MODERNIZATION AT CURRAN MIDDLE SCHOOL FOR:

BAKERSFIELD CITY SCHOOL DISTRICT

ROOF PLAN
BUILDINGS A, B & C

A-141

A1 ROOF PLAN BUILDING 'A', 'B', & 'C'

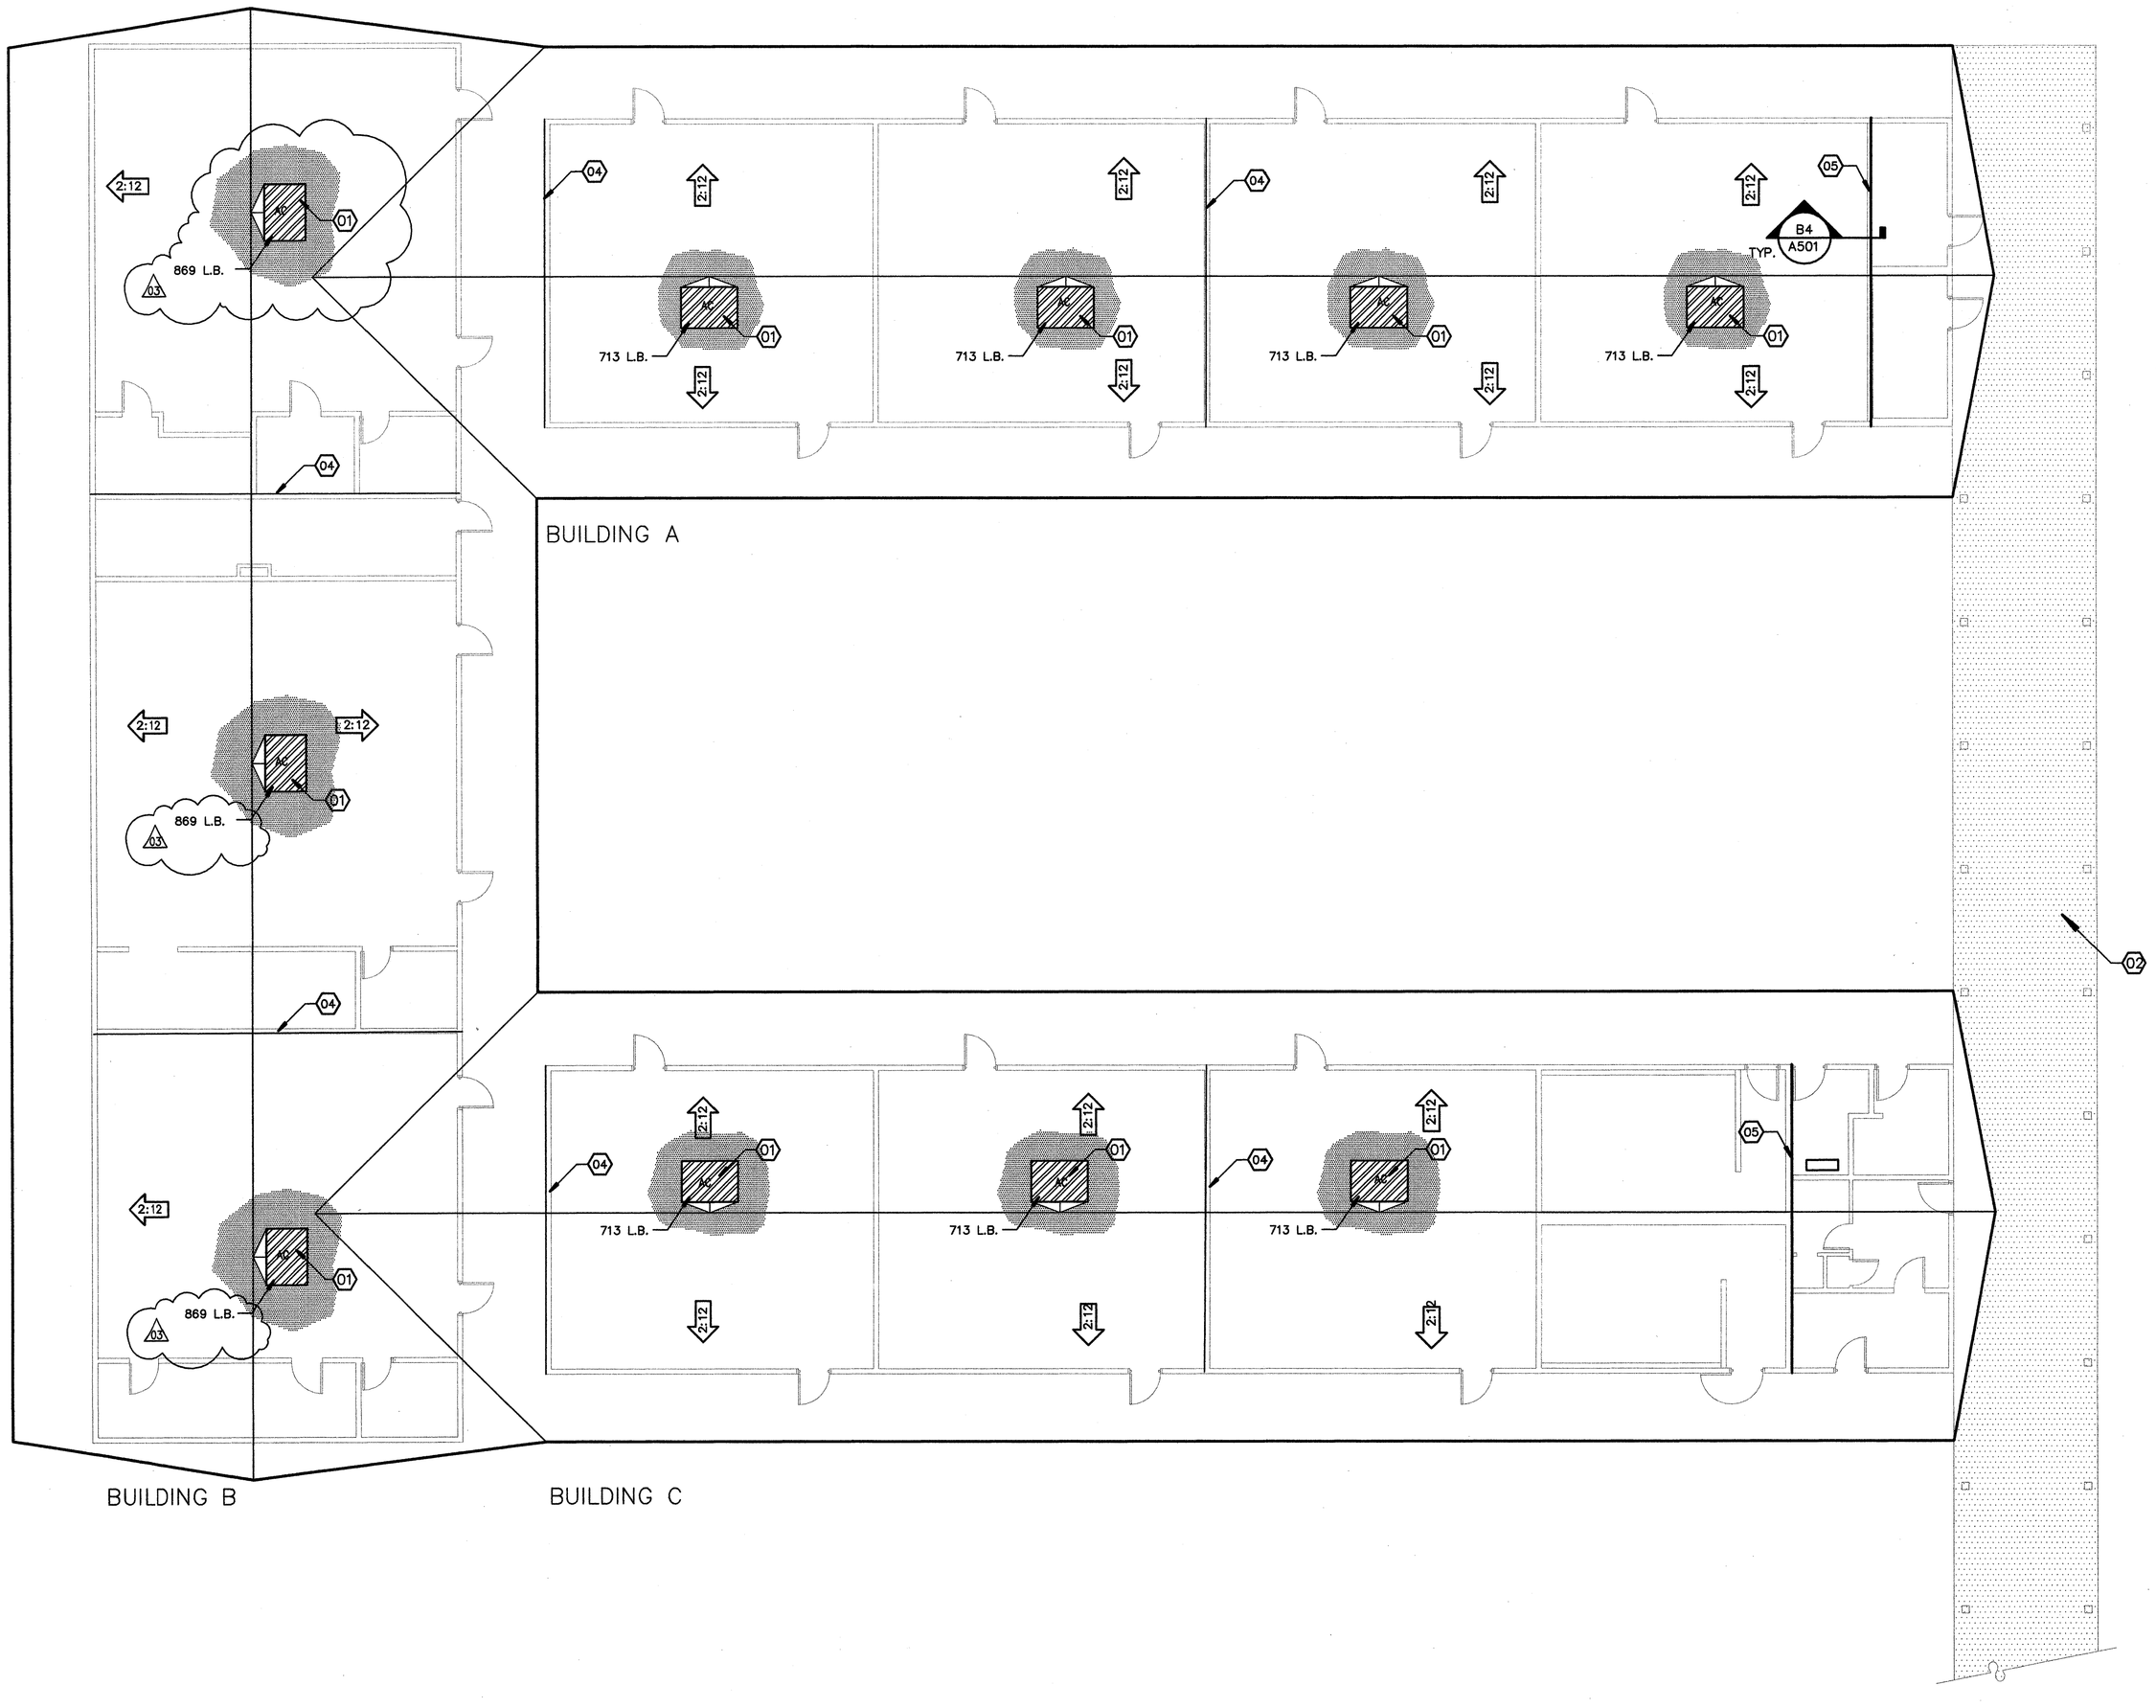
~~03 (E) EVAPORATIVE COOLER UNIT TO REMAIN~~ OMIT 03

03 05 PROVIDE INSTALL 1/2" GYP.BD. DRAFT STOP SEE DETAIL B4/A501

Item No. 17: Refer to Sheet A -141 ADD #13

Revise weight indication of HVAC units on building "B" to read 869 lbs each.
Revise keynote #2 to read "existing covered walk to be removed by others."
Omit Keynote #3.
Revise Keynote #5 to read "provide install ½" gyp board draft-stop see detail B4/A-501."

Item No. 2: Refer to Sheet A-141
ADD #4 Omit HVAC unit over Mechanical Room E-118 and HVAC unit over Passage room E-106; coordinate HVAC requirements with revised Mechanical Plans per addenda 003. The Orientation of HVAC incorrect over Music Room D-119; coordinate with revised Mechanical Plans per Addenda 003. Omit Keynote 03. Revise Keynote 09 to read. "Replace existing platform as required see structural drawings." Add Keynote 09 to all HVAC Units typical.

Item No. 5: Refer to Sheet A-141 through A-144
ADD #7 HVAC replacement, additional information provided per addendum drawing ADD-012.
